1 Products affected

2 Type of change

Product Change Notification				PCN CMFx				
owner	creation date	release date	released by	change order no	rev	page	D40 027 640	
huberth	18.06.2019	09.07.2019	limachcl	2017851	Α	1 of 2	D10-037-610

3 Detailed description of change

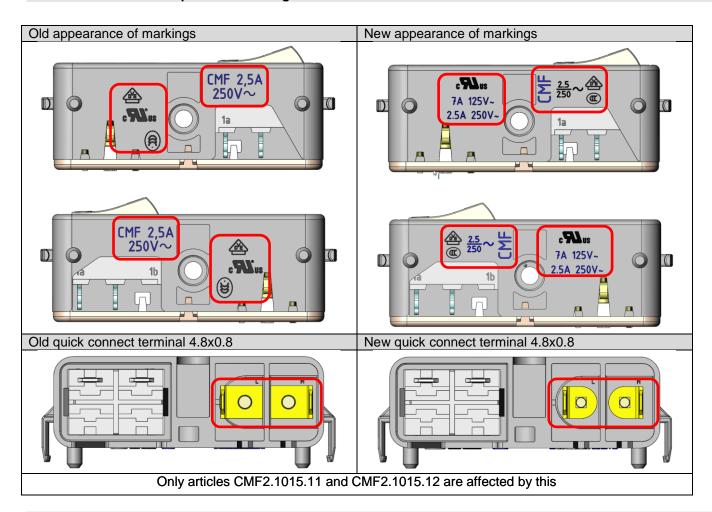
- Change of markings
- Change of quick connect terminal

- Standard update to UL/CSA 60320-1
- Quick connect terminal too close to the socket wall (Only applicable for part numbers CMF2.1015.11 and CMF2.1015.12)

The change takes effect in ww30/2019 (Date code 1930 or higher on label) and lasts approx. 6 months depending on the variant. This change has no effect on the validity of the approval certificates.
